Tollway Standard Drawing Revisions

Section F	Sign Structures	
	Standard	**Modification Summary** **Effective: 03/11/15**
	All	Revised detail descriptions to match Tollway Coded Pay Items
		Updated drawings to follow IDOT highway standard levels
	F1	**Overhead Sign Structure Span Type Structure Details**

STANDARD F1-05

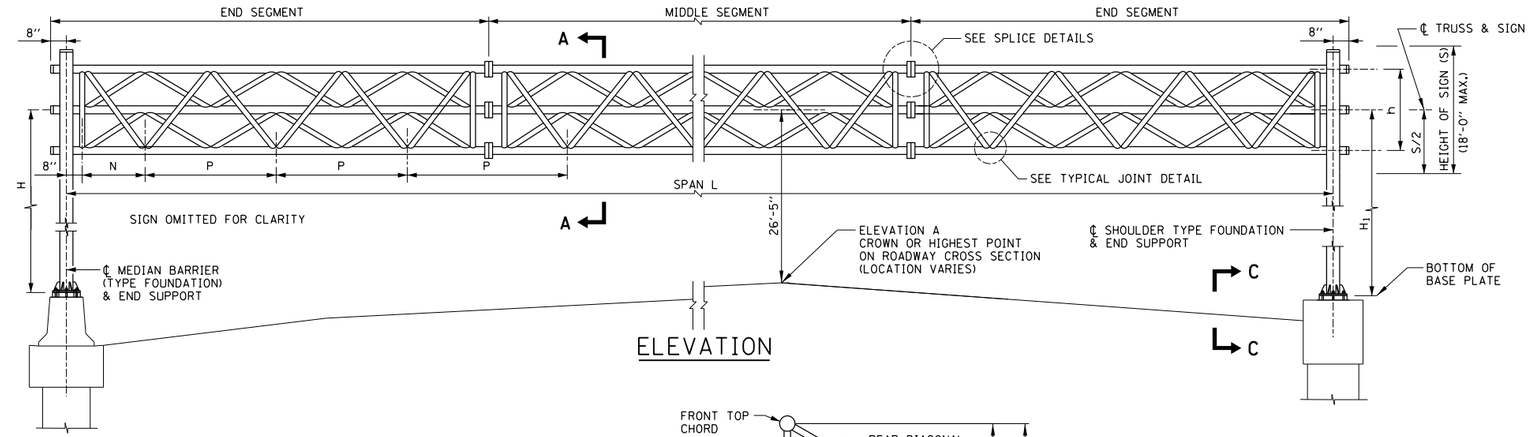
Sheet 1	Standardized height of truss span above roadway
	Sheet 1	Deleted General Note 2; renumbered notes
	Sheet 1	Fabrication notes; added note 1; renumbered notes

Sheet 1	Added typical joint weld detail for truss span
	Sheet 1	Specified weld filler alloy requirements for aluminum truss welds
	Sheet 2	Revise angle symbol

STANDARD F1-05

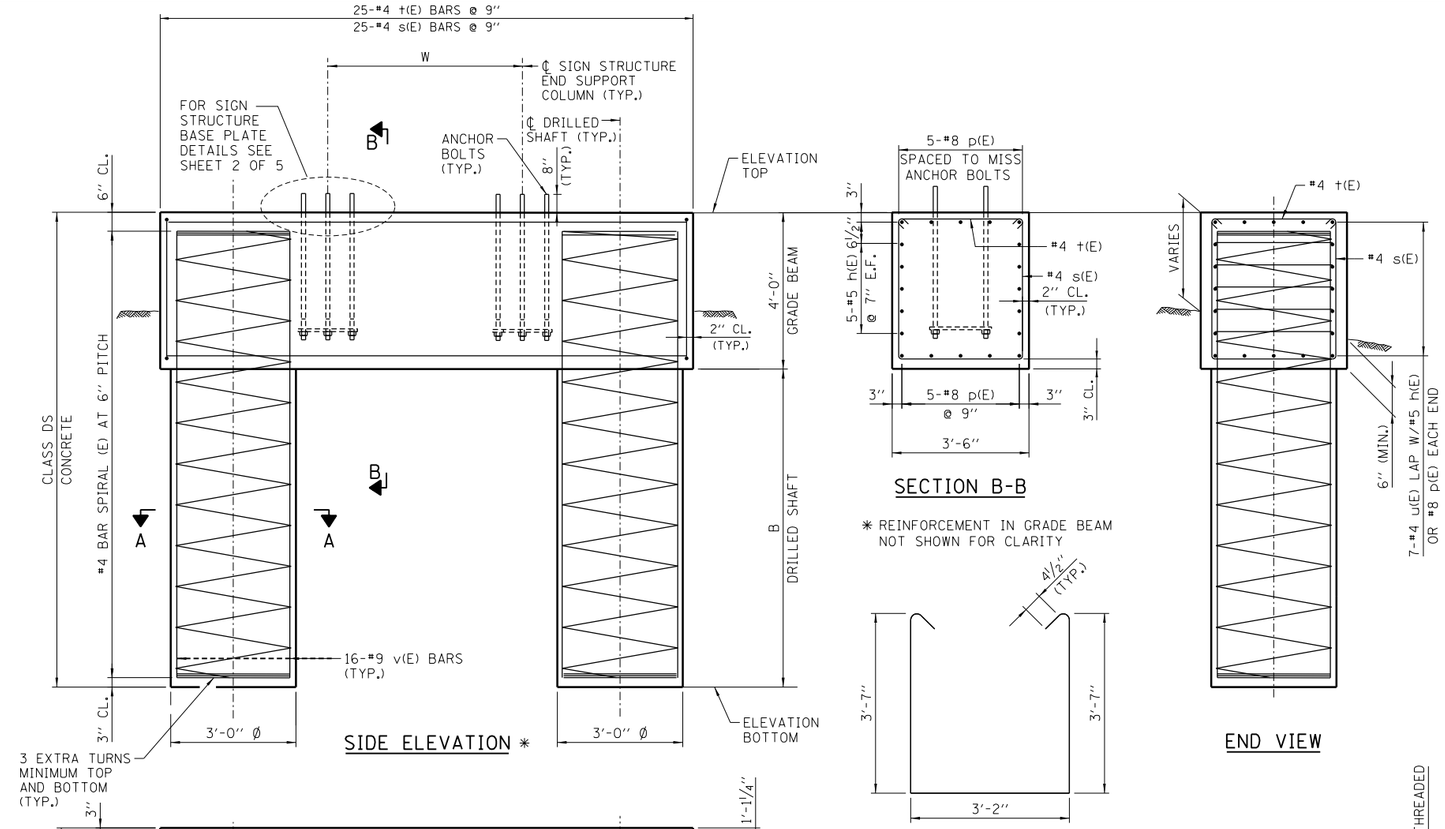
Sheet 2	Revised detail formulas sheet 2, Details "A","B","C"
	Sheet 3	Removed grounding details
	Sheet 3	Added site grounding requirements note 7, Sheet 3

7. SITE GROUNDING ELECTRODE SYSTEM TO BE PROVIDED AS INDICATED ON THE PLANS.
8. NO SONOTUBES OR DECOMPOSABLE FORMS SHALL BE USED 6" BELOW THE FINISHED GROUND LINE. PERMANENT METAL FORMS OR OTHER SHIELDING MAY NOT BE LEFT IN PLACE BELOW THE ELEVATION WITHOUT THE ENGINEER'S WRITTEN PERMISSION. EXCAVATIONS SHALL BE DEWATERED BEFORE CONCRETE PLACEMENT IF DIRECTED BY THE ENGINEER AT NO ADDITION COST.

STANDARD F4-06

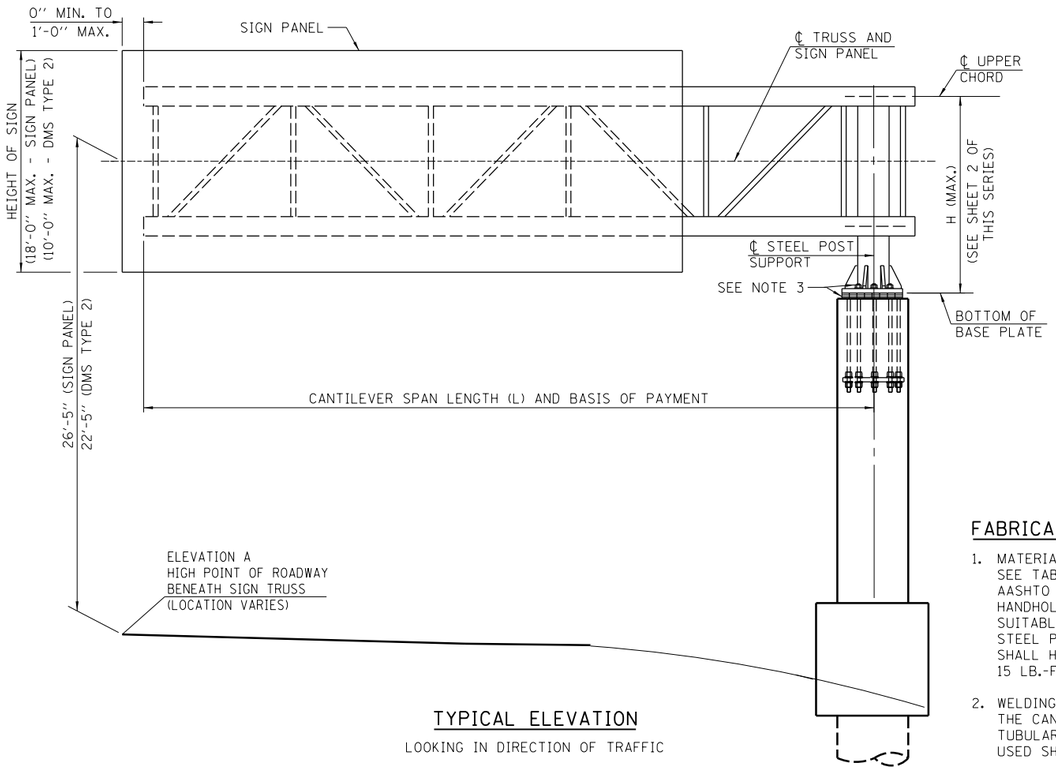
Sheet 4	Clarified Preformed Joint Filler limits at barrier/foundation interface, Section D-D
	F4	**Overhead Sign Structure Cantilever Type**
	Sheet 1	Standardized height of truss span above roadway

Sheet 1	Deleted General Note 2; renumbered notes
	Sheet 1	Removed General Note 10
	Sheet 1	Revised surface finish, General Note 7
	Sheet 4	Removed grounding details

6. ALL STEEL PLATES, SHAPES AND PIPE SHALL BE HOT DIP GALVANIZED AFTER FABRICATION IN ACCORDANCE WITH AASHTO M111.
7. PROVIDE RUBBED SURFACE FINISH FOLLOWED BY CONCRETE SEALER APPLICATION ON ENTIRE SURFACE OF CONCRETE COLUMN AND NORMAL SURFACE FINISH ON GRADE BEAM, EXCEPT BOTTOM SURFACE. COST IS INCLUDED IN THE COST OF "FOUNDATION FOR OVERHEAD SIGN STRUCTURE, CANTILEVER TYPE".

STANDARD F14-01

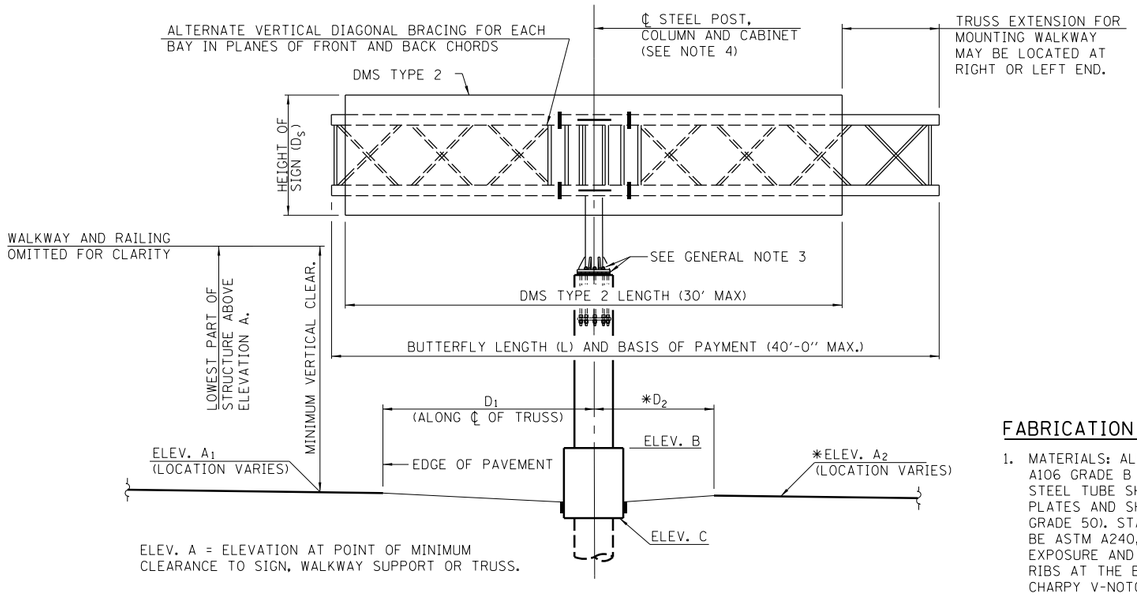
Sheet 8	Revised length of barrier transition and updated quantities
	F14	**Overhead Sign Structure Butterfly Type Structure Details**
	Sheet 1	Eliminated General Note 2, renumbered notes

Sheet 1	Revised surface finish, General Note 6
	Sheet 4	Removed grounding details
		Added Site grounding requirements; Note 1
	Sheet 6	Revised Taper, Barrier Transition
		Removed conduit size, type and number; Added note 3
	F15	**Overhead Sign Structure Monotube Type (Steel) Structure Details for AET Ramp**
		DB14-13
	F16	**Overhead Sign Structure Monotube Type (Steel) Structure Details For Cash-IPO Ramp**
		DB14-13
	F17	**Overhead Sign Structure Span Type (Steel) Structure Details**
		Revisions from DB14-07

6. PROVIDE RUBBED SURFACE FINISH FOLLOWED BY CONCRETE SEALER APPLICATION ON ENTIRE SURFACE OF CONCRETE COLUMN AND ALL SURFACES OF CRASHWALL, EXCEPT BOTTOM SURFACE. COST IS INCLUDED IN THE COST OF "FOUNDATION FOR OVERHEAD SIGN STRUCTURE, BUTTERFLY TYPE."

STANDARD F17-00

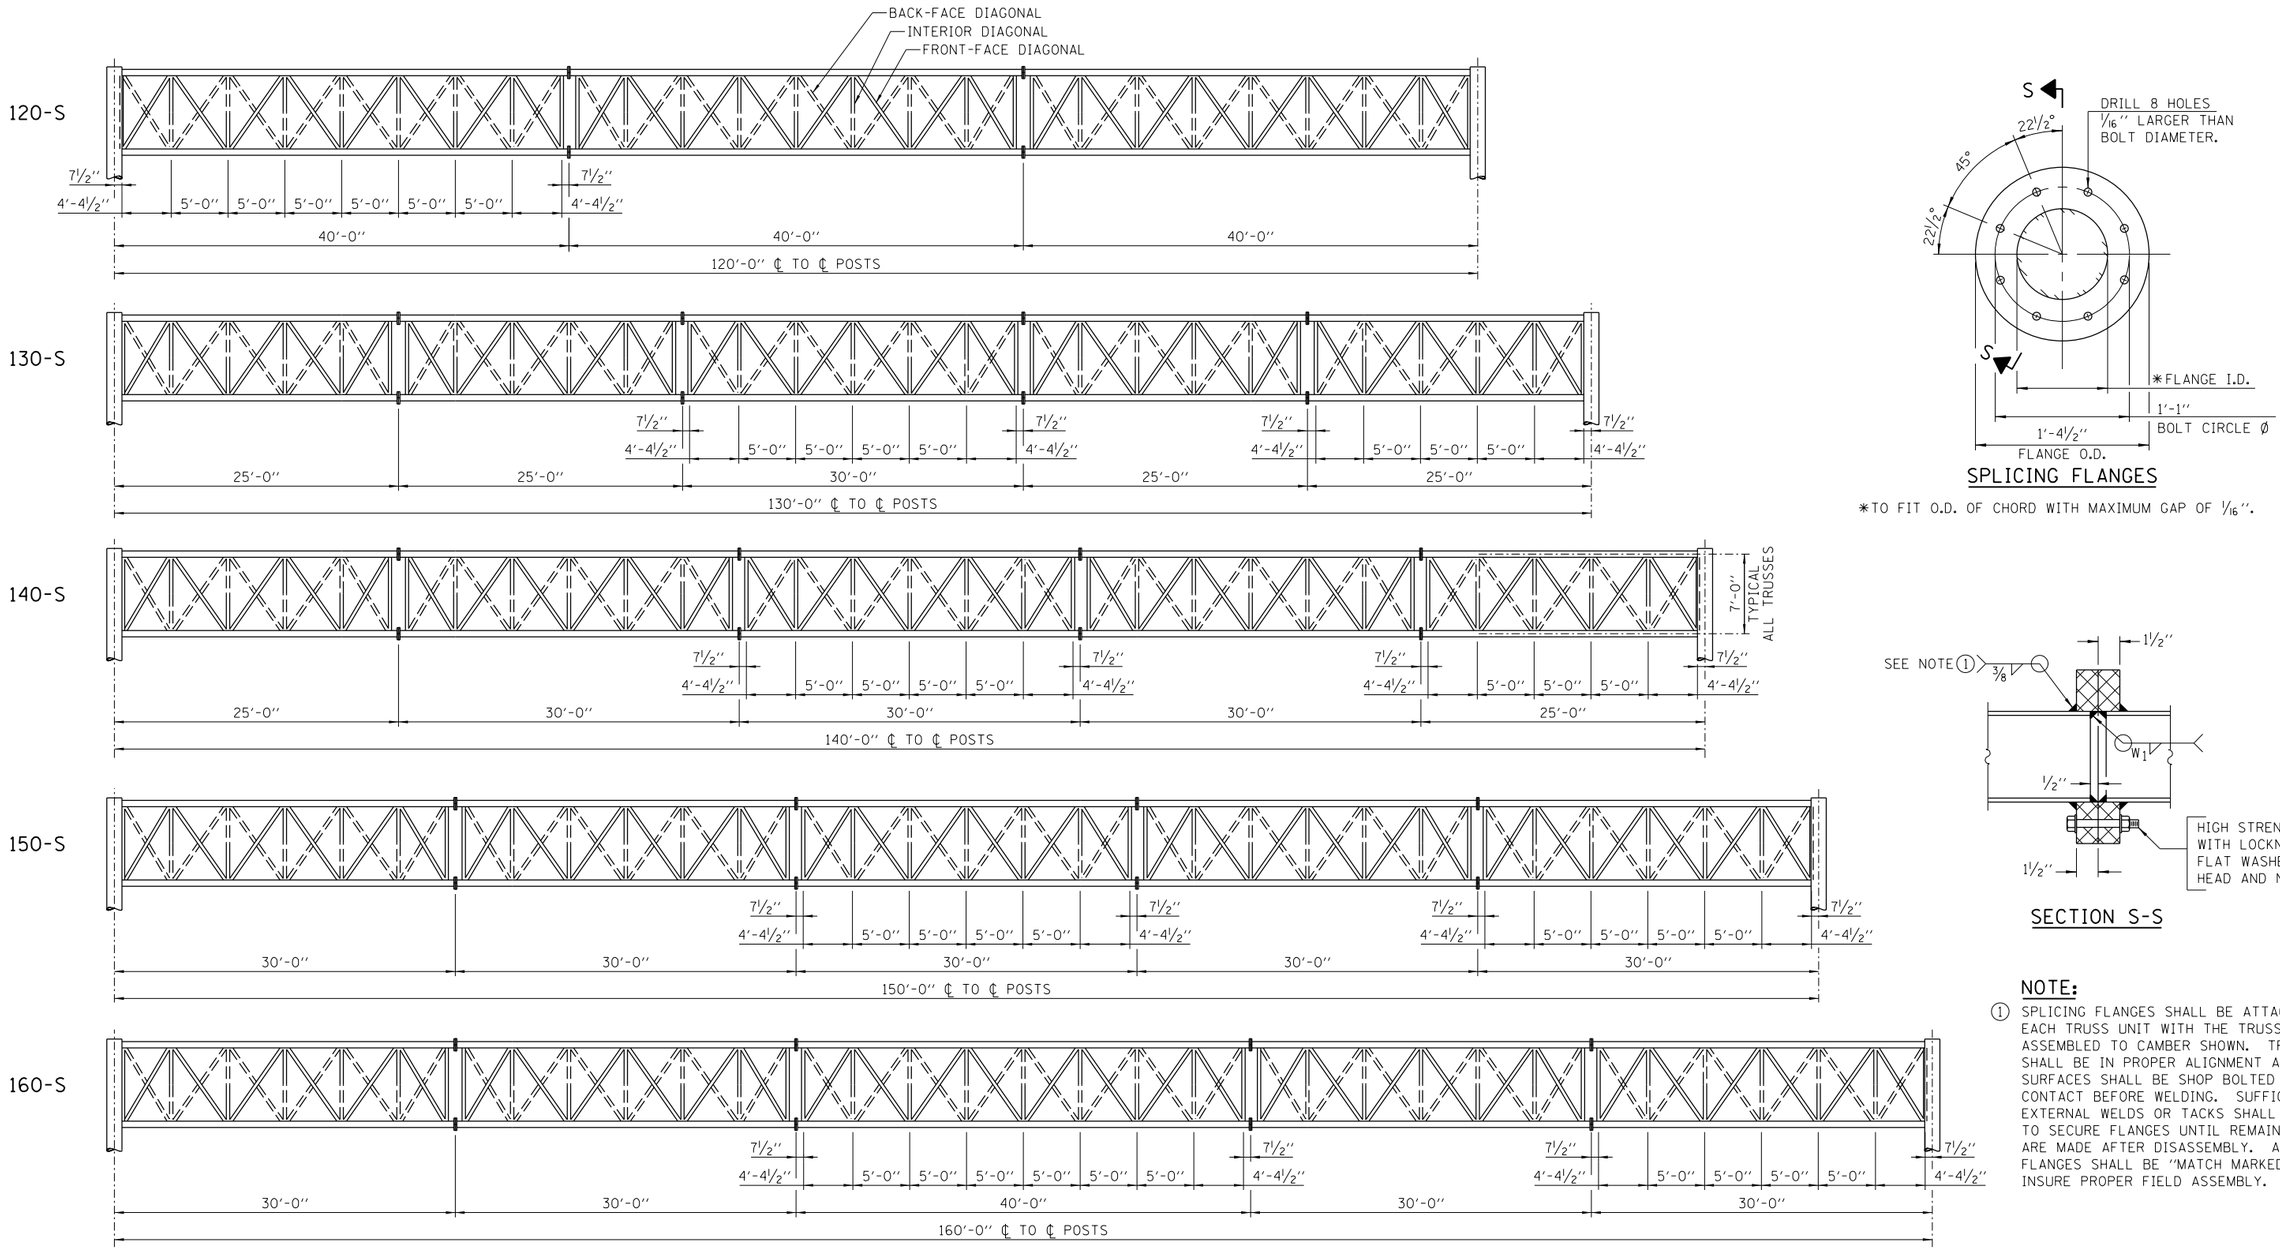
Sheet 1	Revised drawing to show crown in roadway and added clarification note
	Sheet 1	Eliminated General Note 2, renumbered notes
	Sheet 7-9	Removed grounding details
